CITY OF CONWAY, ARKANSAS HISTORIC DISTRICT COMMISSION

HISTORIC DISTRICT COMMISSION

707 Parkway Street - Commercial Remodel

950 Watkins Street - New Single-Family Residence

1 SITE PLAN
1" = 10'-0"

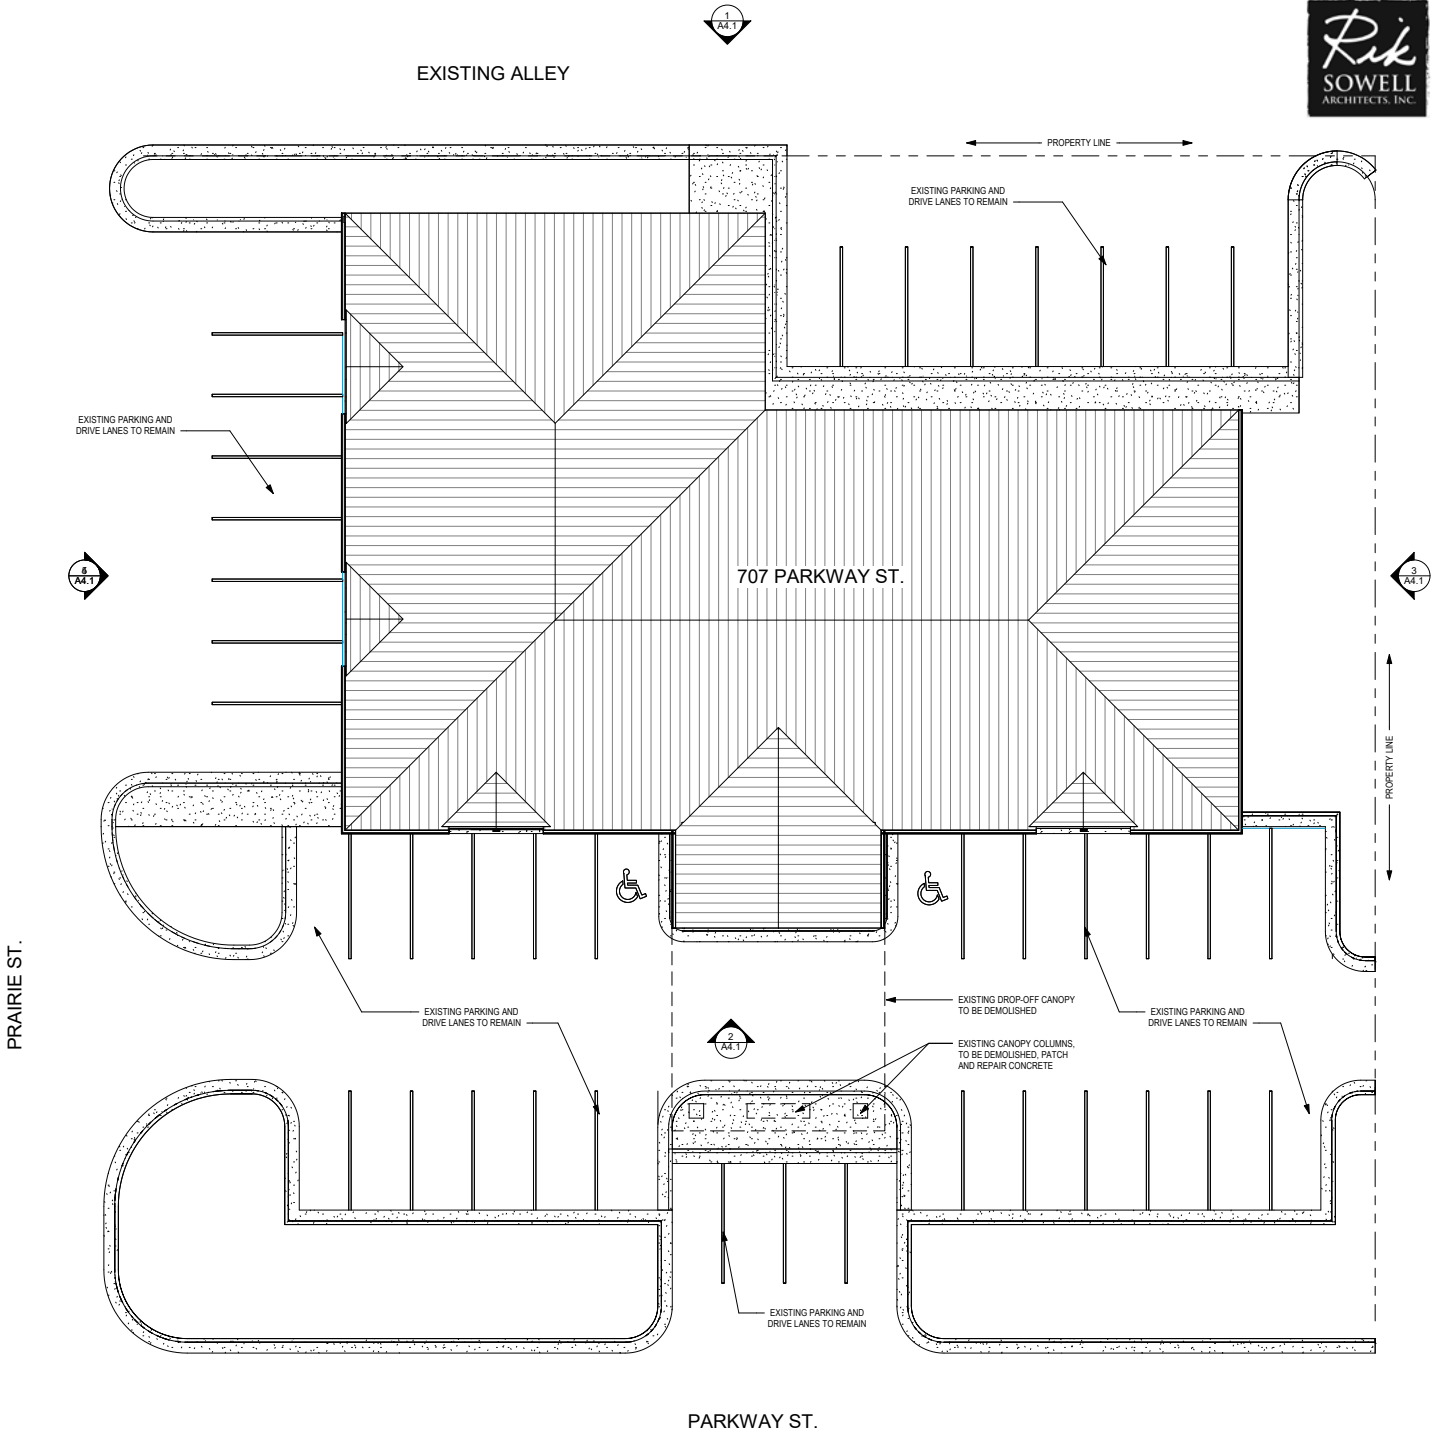
No loading dock is proposed. No dumpster enclosure is shown on elevations but one is existing at the site. It is unclear whether it will be retained.

The design does not show the location of mechanical equipment. It is currently on the western side of the structure facing an alley and is visible from the public right of way.

Signage is indicated near the entrance on a column.

1. Applicant must obtain all applicable building permits* if/when a Certificate of Appropriateness is granted.
**Applicant shall provide proof of appropriate licensure of professionals performing work to the Building Permits Department*
2. Eighty-five percent (85%) of all first story glazing shall be transparent.
3. All signage shall comply with Old Conway Overlay District guidelines and regulations detailed in Article XII of the Conway Zoning Code. All signage is permitted separately from all review and building permit processes.
4. Some level of exterior building/accent lighting should be provided and shall be inward, downward, and shrouded to stay within the bounds of the property.
5. A dumpster enclosure made with materials that are similar to and complement the primary building is required.

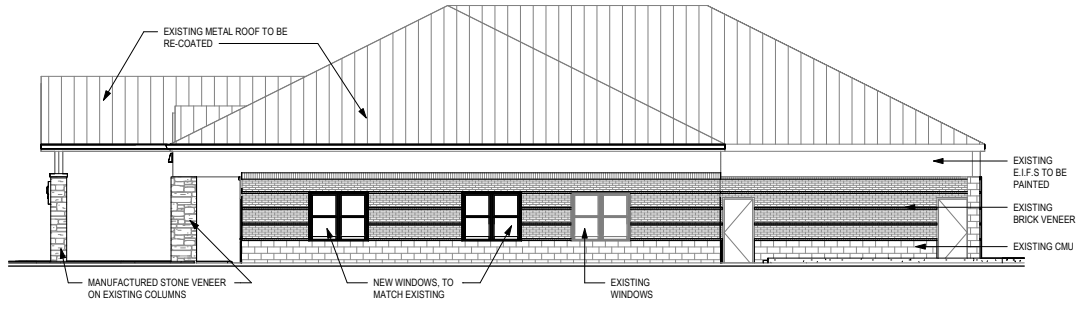
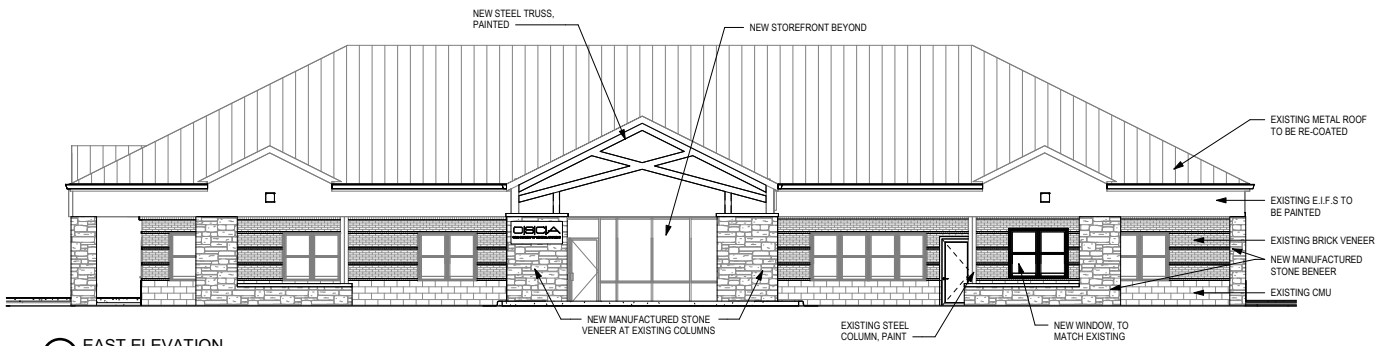
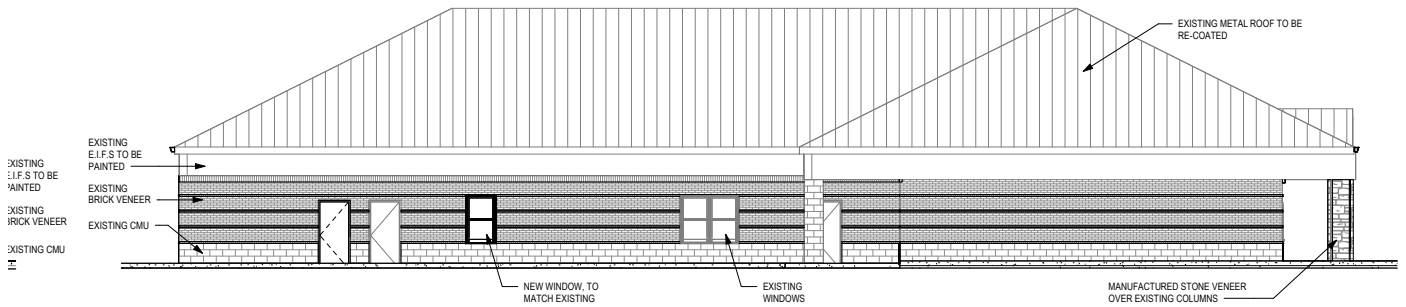
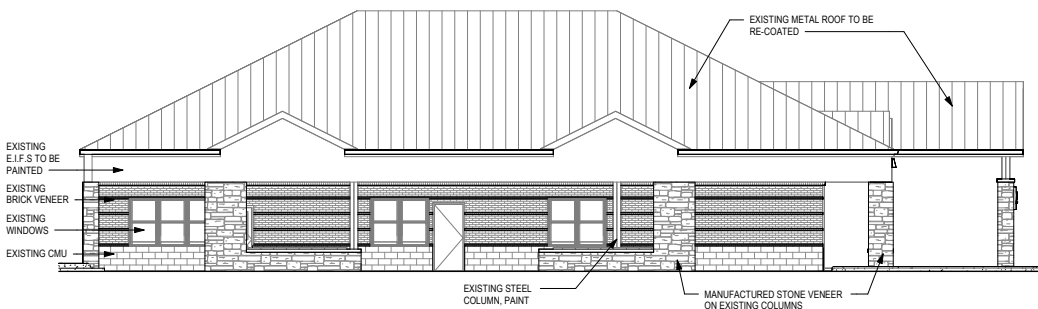
This is a single-story building. All four facades incorporate an appropriate amount of articulation. Less than 2/3 of the first story are windows. Windows are being added to the north, west, and east elevations.

Existing windows appear to follow the required amount of transparency. Applicant is proposing to add stone veneer to columns, a painted, steel truss above the entrance and will recoat the metal roof.

The primary entrance corresponds to the parking area and is set back from the street frontage. Columns and a painted truss emphasize the building entry. Secondary entries are located on the south elevation and are also set back from the street.

It is unclear if any exterior building or accent lighting is proposed.

FRONT ELEVATION

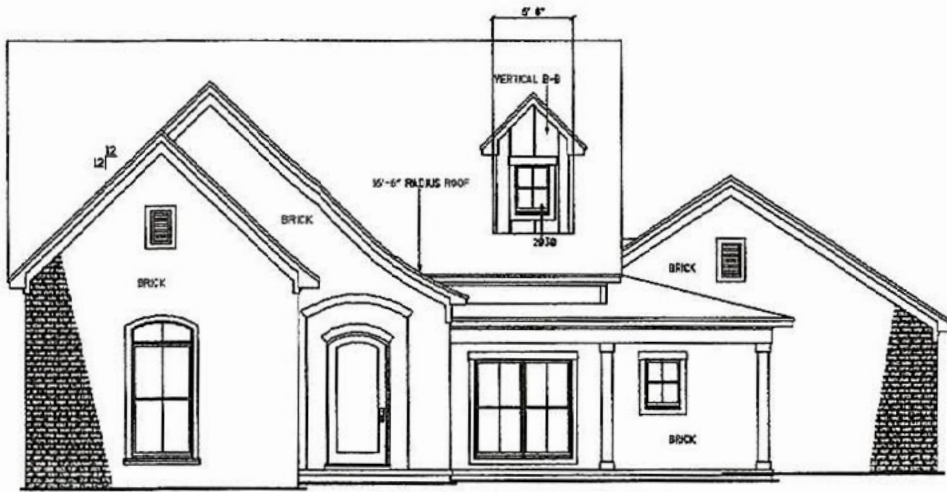
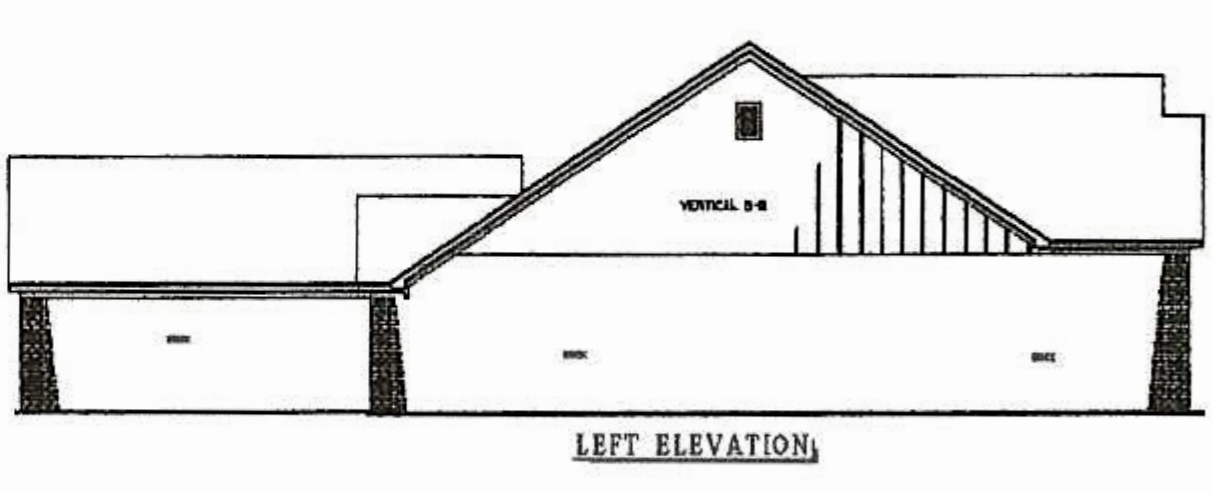
The floor plans show one window on the left side of the proposed residence, but the elevations do not show any windows on the left elevation. More windows could be included on the left elevation. (The applicant expressed to staff that because this elevation faces their neighbor's fence, more windows were not included on the left elevation.) The right elevation would also benefit from one additional window. One to two dormers on the rear elevations of the attic may also add to the rhythm.

All porches exceed a 6-foot depth. The entries contain decorative elements. Windows appear to be two-over-two and will need to be true divided light.

No shutters are being proposed which is desirable. The applicant is proposing a gable roof. The roofing material is not specified.

- Revised elevations showing additional windows on the left and rear elevations.
 - A site plan showing the location and type of trees to be planted to replace those being removed.

- 5-foot wide sidewalks shall be constructed along Watkins St and Cross St with a 5-foot greenspace.
5. Windows shall be at least one-over-one (not fixed windows). If muntin bars are used, they must be true divided lights.

9. Roofing shall be asphalt or composition type shingles; metal roofing is prohibited.

Tree Removal Plan

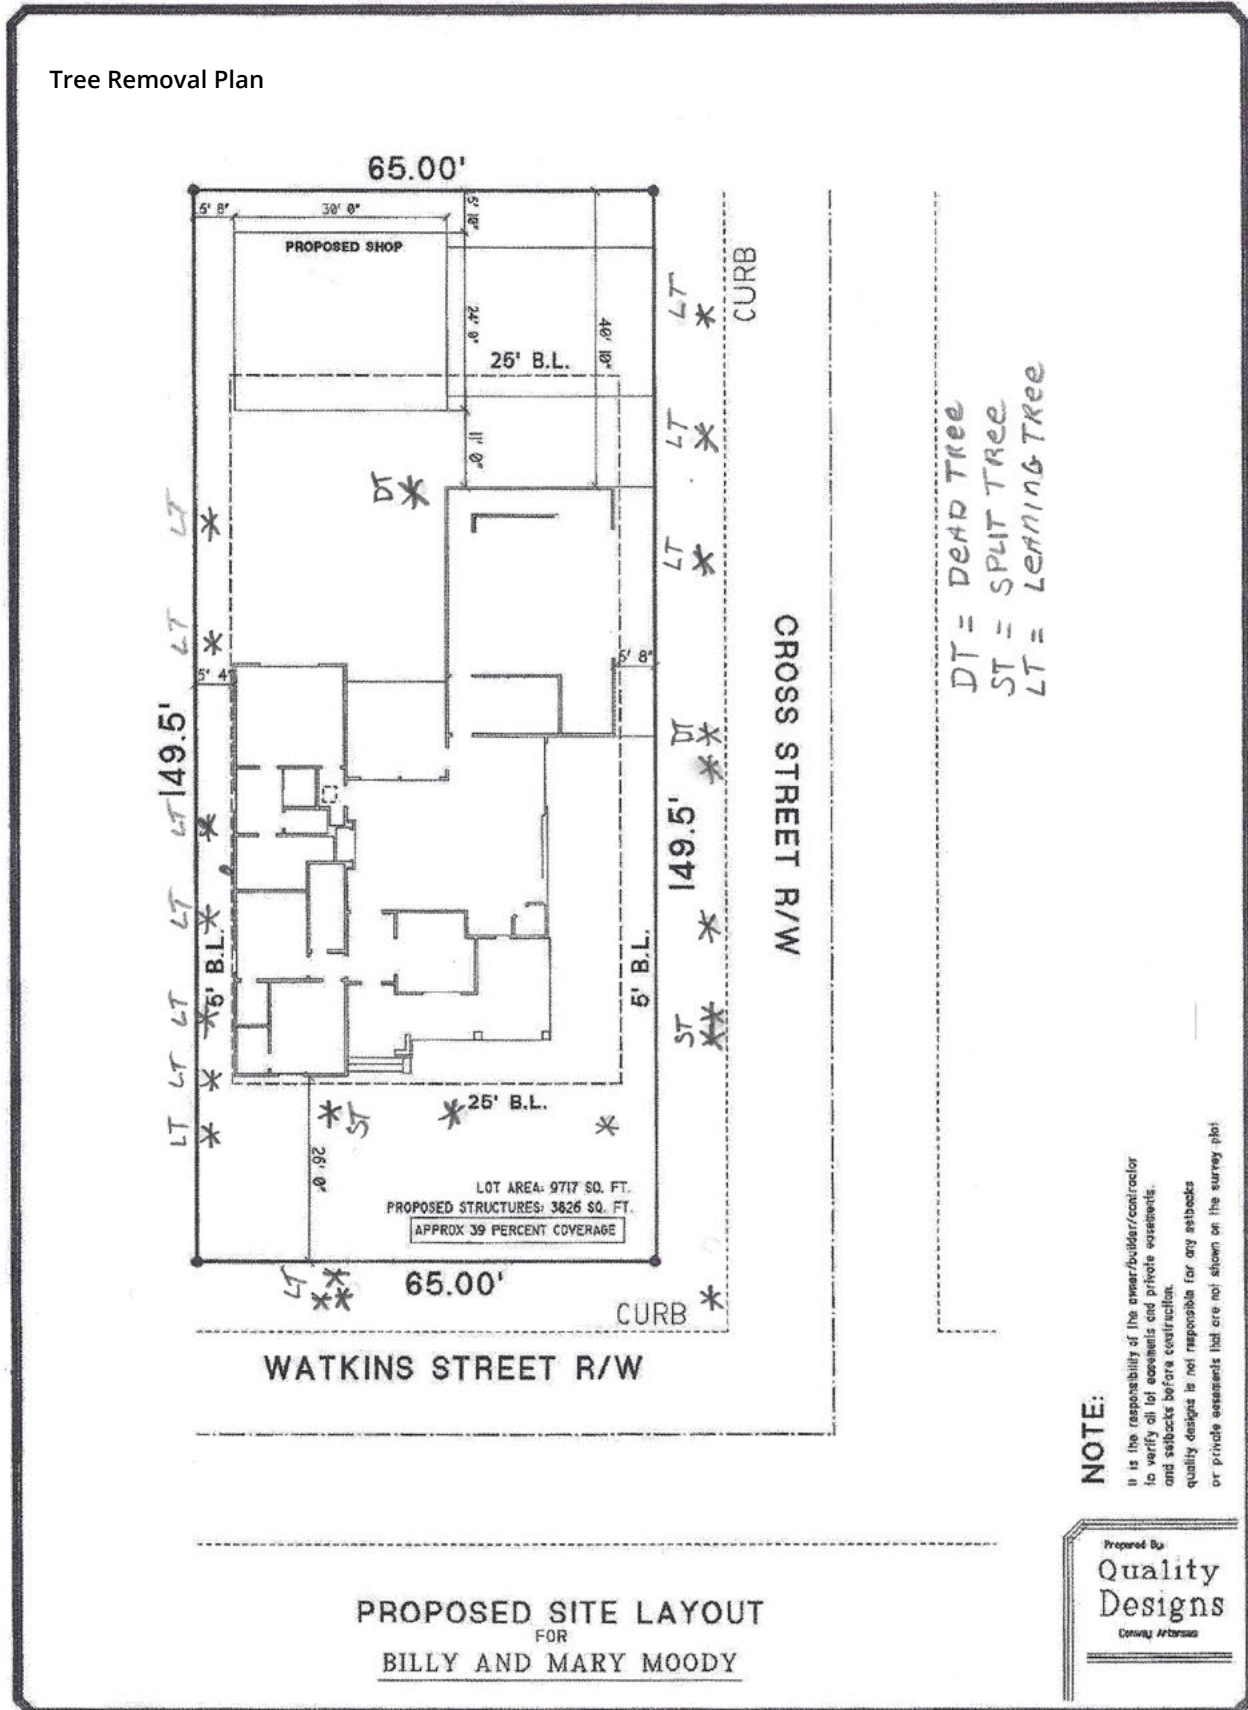
The applicant wishes to remove all trees from the property and has provided staff with the following statement:

"Most of the trees are dead, leaning, diseased, near utilities and one is actually growing in the storm drain. Some limbs have already fallen through the roof on this property."

Staff recommends that at least one canopy tree be retained if feasible. Canopy trees will need to be replanted at a rate of one tree for every 30 feet of street frontage. The property line along Cross St is 149 feet. The street frontage on Watkins is 65 feet. Taking into consideration the need to be 15 feet from a street intersection and the orientation of the residence, staff recommends the planting of one tree on Watkins St and 2-3 trees on Cross St (less if any existing canopy trees can be retained). A canopy tree will also need to be planted in the back yard to replace one being removed, or saplings of a canopy tree already on-site may be retained instead.

- One canopy tree must be present on Watkins St; 2-3 canopy trees on Cross St; at least one canopy tree in the rear yard. This requirement can be met through plantings, retained saplings, or mature trees if they are species which reach a maximum height between 40 and 60 feet.

PROPOSED SITE LAYOUT
 FOR
 BILLY AND MARY MOODY

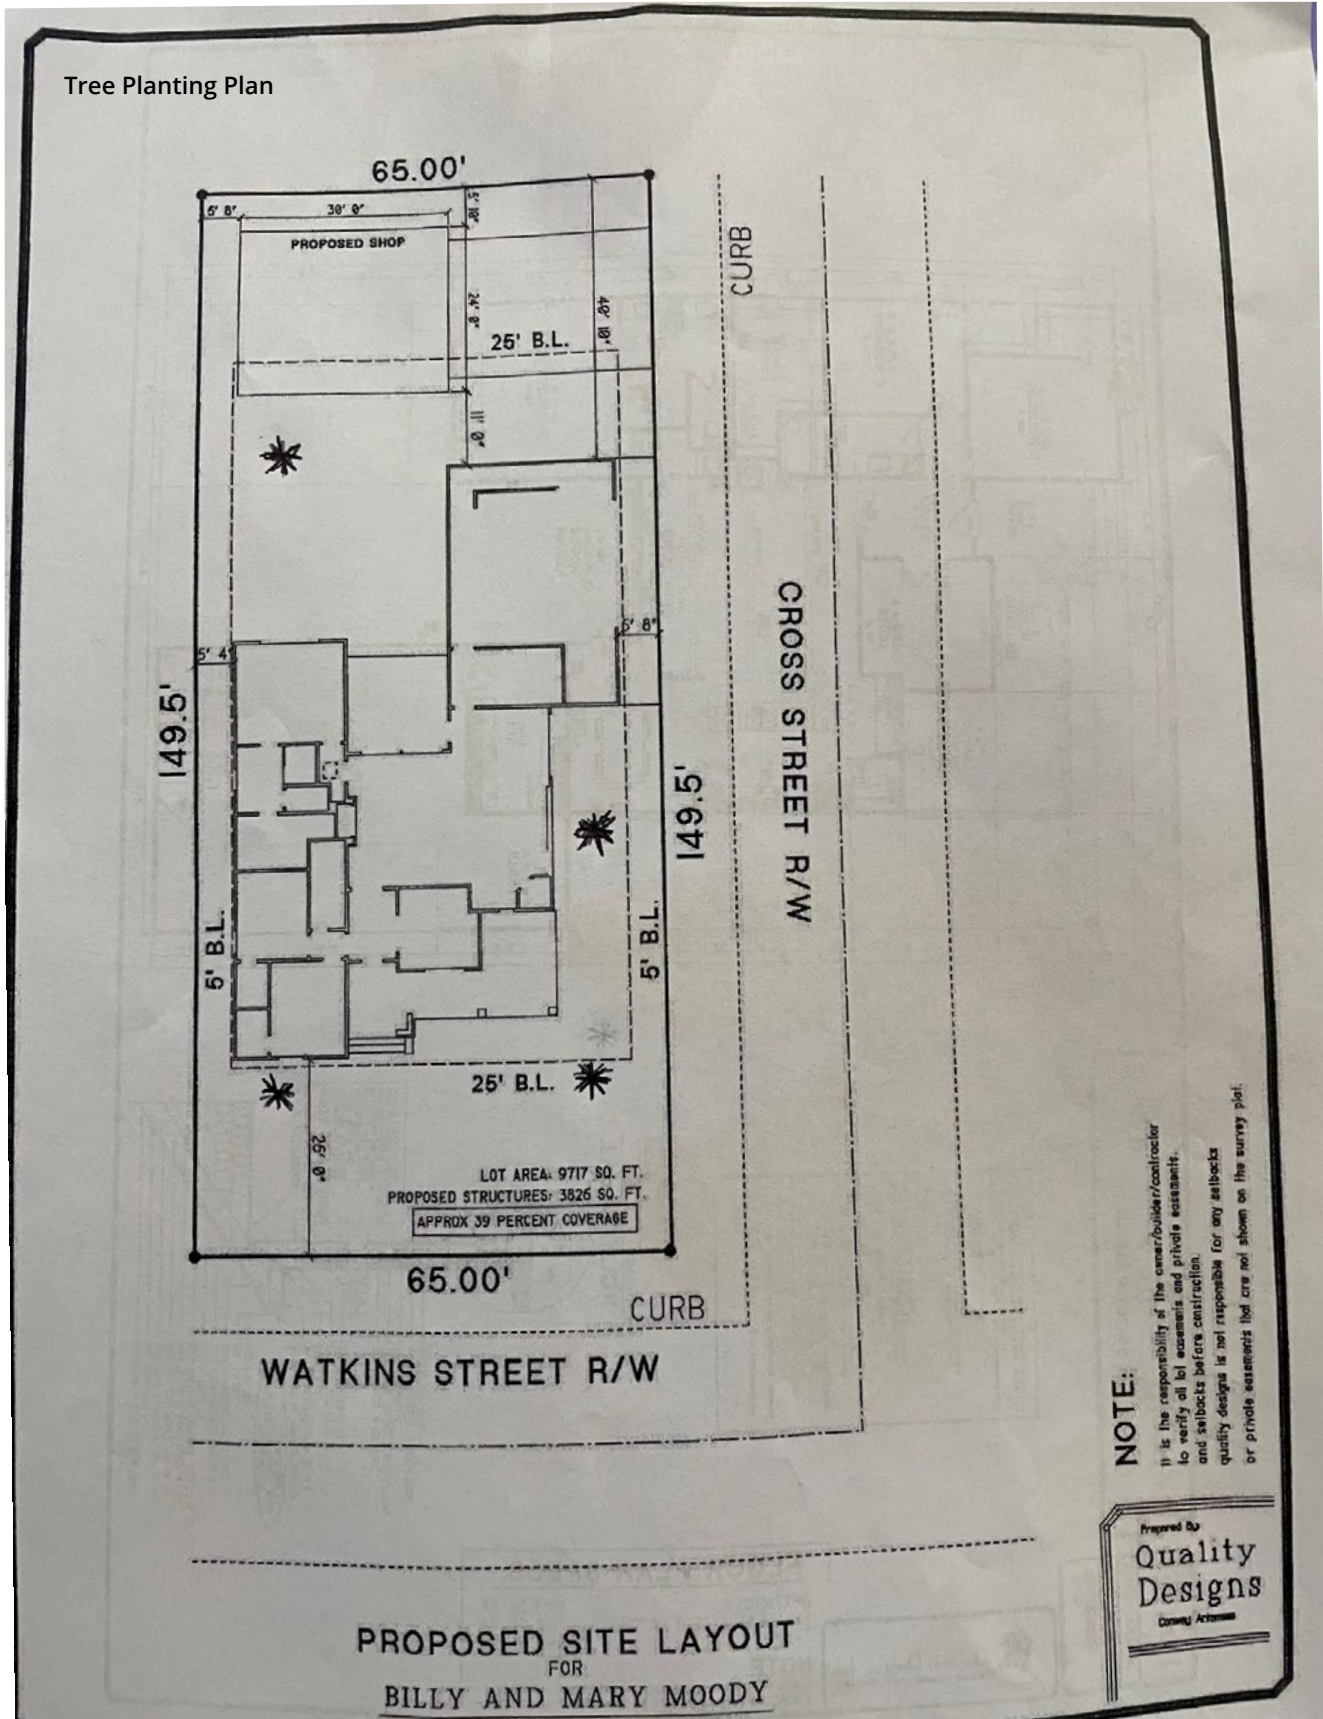
The average front setback for the area is 22 feet, based on ten homes on the same block. The applicant is proposing a front setback of 26 feet. To comply, the house will need to have a setback between 18 - 25 feet. The proposed setback exceeds the requirement by one foot. Given that the measurements are made using aerial images, it is likely there is an error of a foot ± and a front setback of 26' is supportable.

The secondary front setback is 8ft; the side yard setback is shown as 5'-4" and the rear setback is 40 feet. The structure will need to be a minimum of 6 feet from the interior side property line and 8 feet from the exterior side property line (Cross St frontage).

The shop is located at the rear of the principal building; 5'-8" from the interior side yard and 5'-10" from the rear property line.

The applicant has not shown a driveway from Cross St to the garage. One will need to be provided in the form of concrete, concrete pavers, or permeable pavers.

Sidewalks are not shown on the proposal. Construction of a 5-foot sidewalk is required.

No HVAC equipment is shown on the site plan.

2. Prior to issuance of a Certificate of Appropriateness (COA), the applicant shall provide planning staff with the following:
 - A revised site plan showing the primary residence as being at least 6' from the interior side property line and at least 8 feet from the exterior side property line (Cross St frontage).

- Revised side plan indicating the location of the driveway and its material type (driveway must be between 8 - 12 feet in width and composed of concrete, concrete ribbon, or permeable pavers)
